July 30, 2010
GO2-10-099

Subject: **COLUMBIA GENERATING STATION, DOCKET NO. 50-397
RESPONSE TO REQUEST FOR SUPPLEMENTAL INFORMATION FOR
COMPLETION OF ACCEPTANCE REVIEW FOR PRNM/ARTS/MELLLA
SYSTEM UPGRADE**

**RESPONSE TO REQUEST FOR SUPPLEMENTAL INFORMATION FOR
COMPLETION OF ACCEPTANCE REVIEW FOR PRNM/ARTS/MELLLA SYSTEM
UPGRADE**

Figure 3-1, PRNM System Communication Diagram

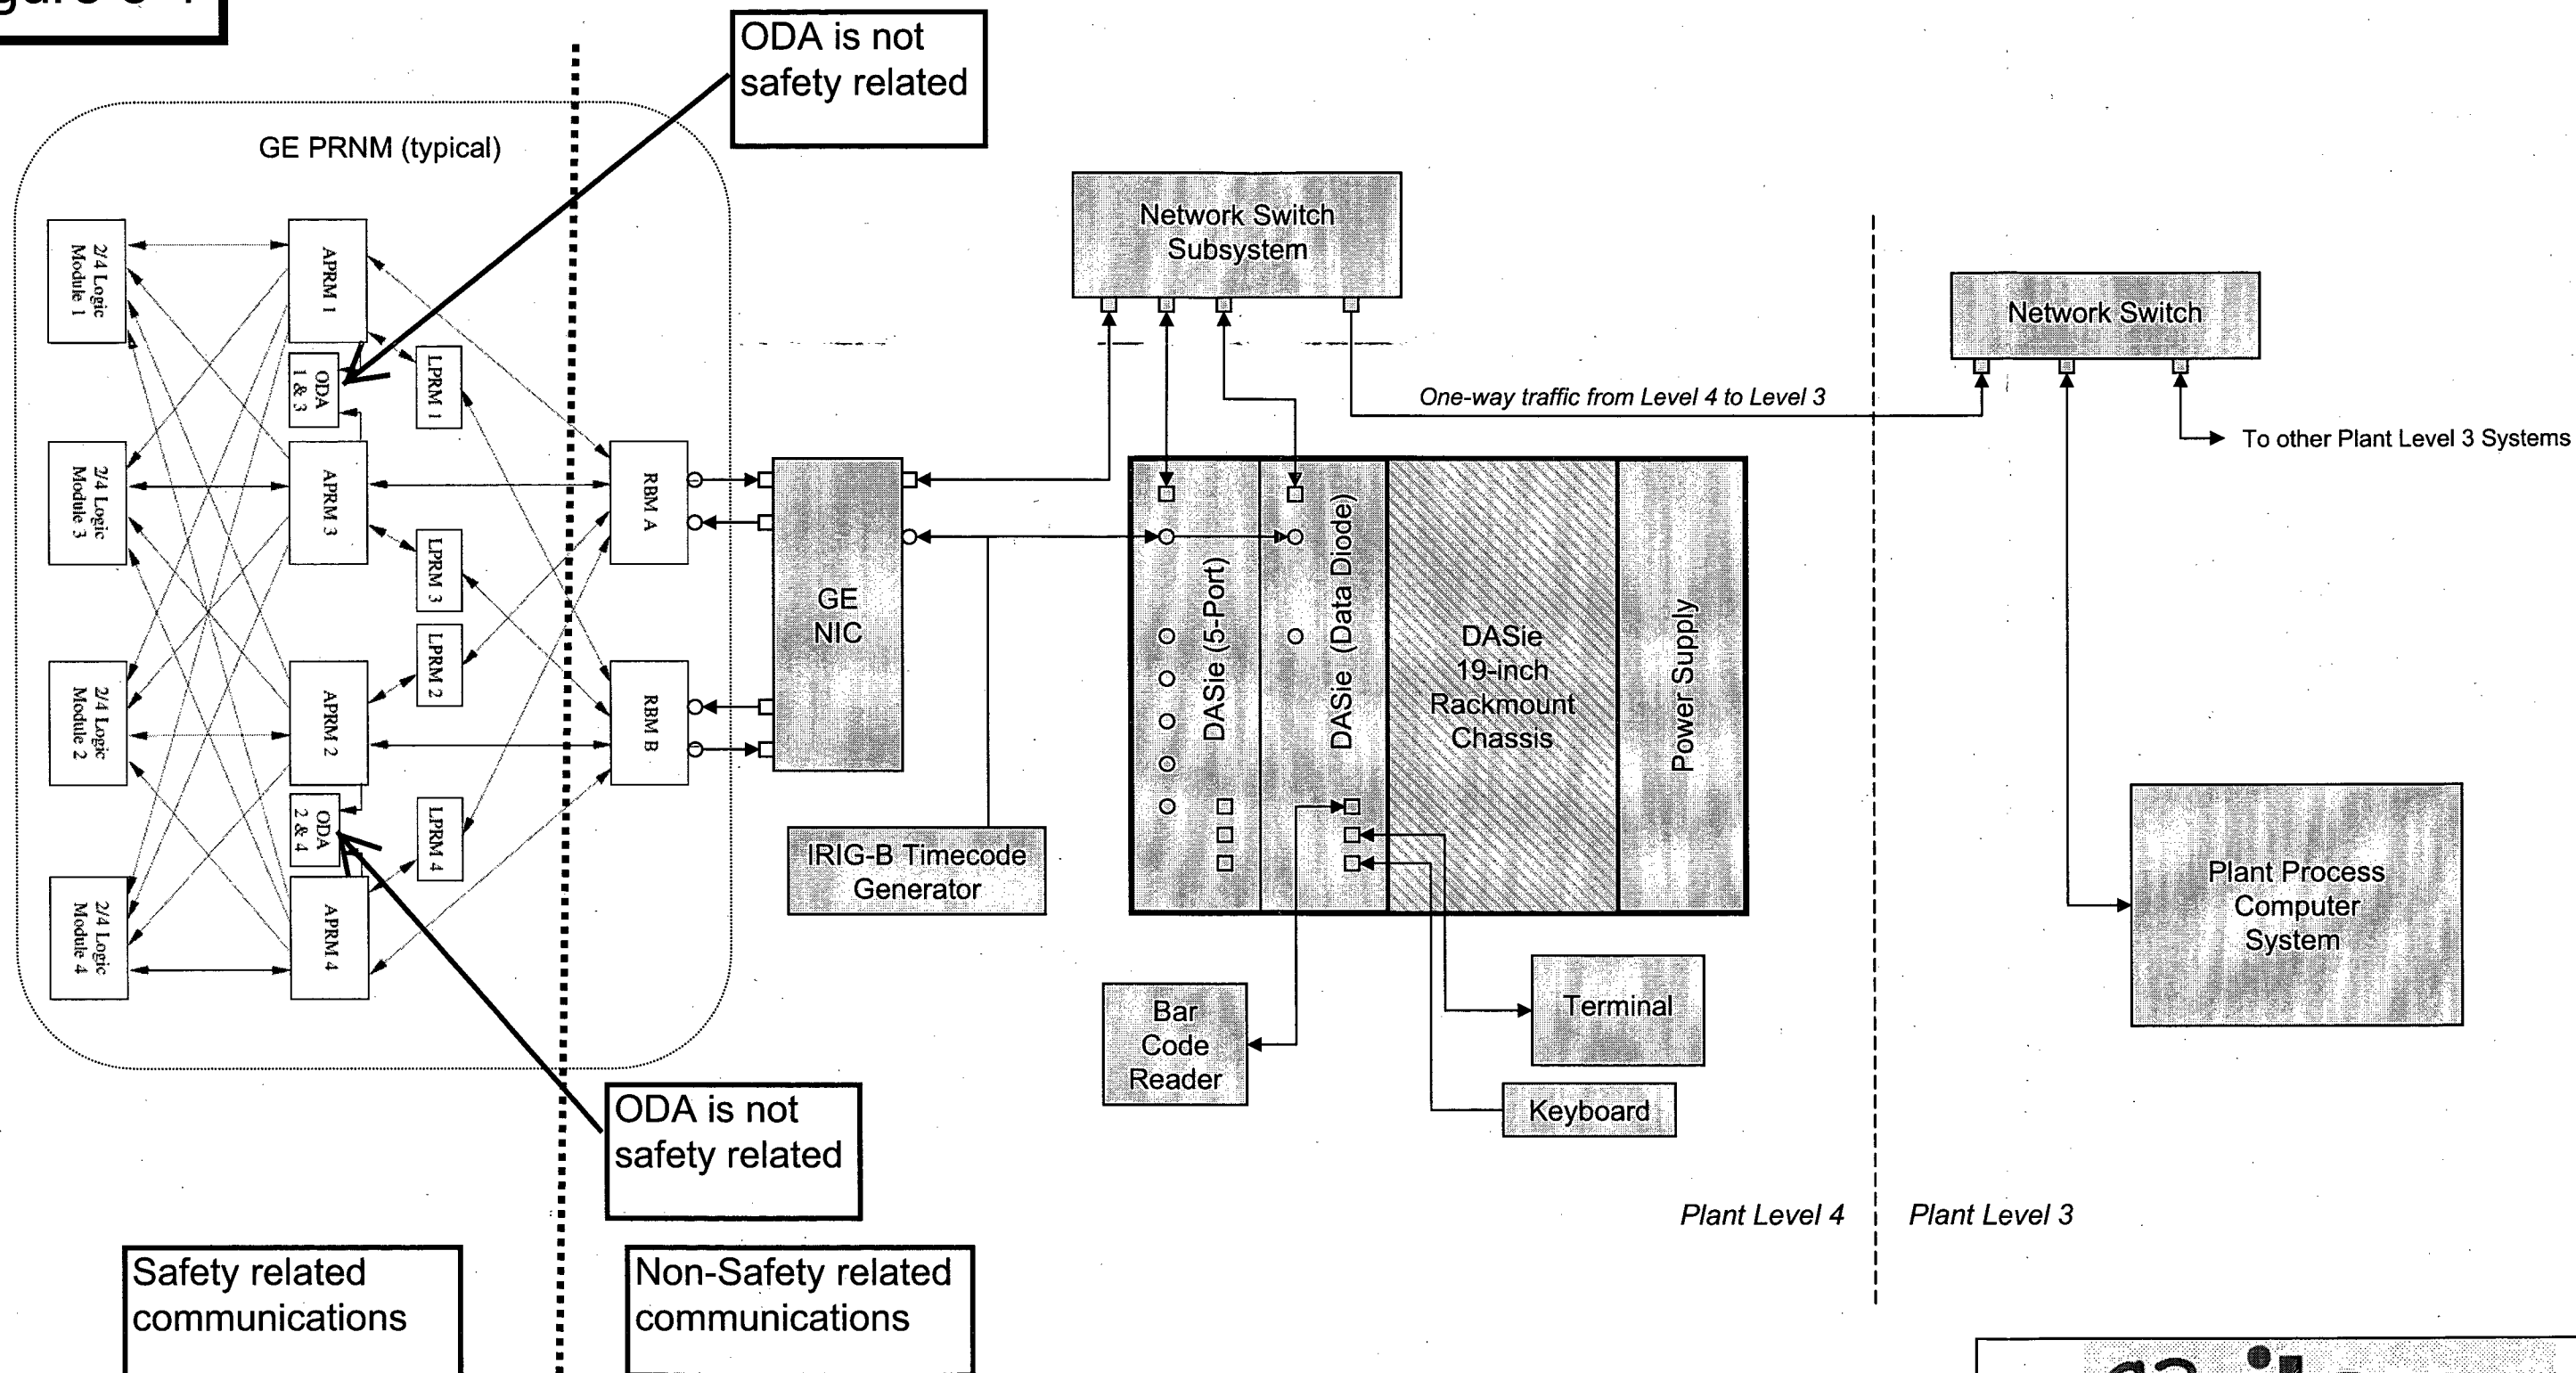
For the CGS application of the GEH NUMAC PRNM/ARTS/MELLLA and OPRM Systems, please clearly identify and define all safety to non-safety data communications, including the data communications between the PRNM System and the Plant Computer and between independent/redundant PRNM channels. For the data communications among the four PRNM channels of the CGS PRNM System, please include a demonstration of compliance with NRC's "Digital Instrumentation and Controls, DI&C-ISG-04, Task Working Group #4: Highly-Integrated Control Rooms—Communications Issues (HICRc), Interim Staff Guidance, Revision 1," dated March 6, 2009 (ADAMS Accession No. ML083310185) (DI&C-ISG-04), for inter-channel communications. For the plant-specific data communications between the CGS PRNM System and the Plant Computer, please include a demonstration of compliance with DI&C-ISG-04 for safety to non-safety communications. Also address any other

communication signals between safety and non-safety systems and/or Plant Computer, as well as any other inter-channel communications.

- Within the PRNM System (safety-to-safety) and for communications involving the Rod Block Monitors (RBMs) and Operator Display Assemblies (ODAs) (safety-to-non-safety)
- Between the RBMs and the NUMAC Interface Computer (NIC) (non-safety-to-non-safety)
- External communications beyond the NIC, including the Plant Process Computer (PPC) (non-safety-to-non-safety)
